NOTICE OF VIOLATION

On August 13, 2024, Energy Safety conducted an inspection of PG&E's WMP initiatives in the vicinity of the city of Mariposa, California. The inspection report is enclosed herewith. Energy Safety found the following violation:

INSPECTION REPORT

Exhibit A: Photo Log Violation 1 Structure ID: 121479485

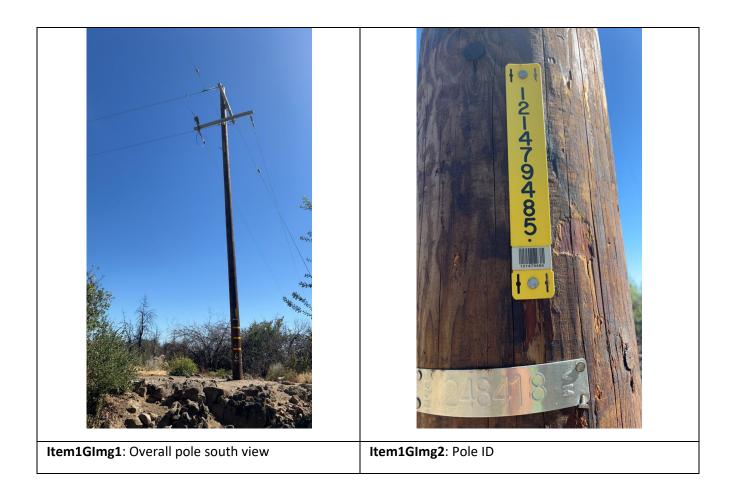
The inspector's observation is documented in Violation 1 photographs, which are attachments to this report. For pole ID 121479485, photo numbers Item1GImg1 and Item1IA1Img1 depict bare conductor and a new crossarm where covered conductor installation was reported as completed.

Image: Abandoned dead end insulator	Item1GImg4: Abandoned triplex insulator lying within vegetation
	vegetation
Item1IA1Img1: New bare wire, crossarms, and cut- out	Item1IA1Img2: South view
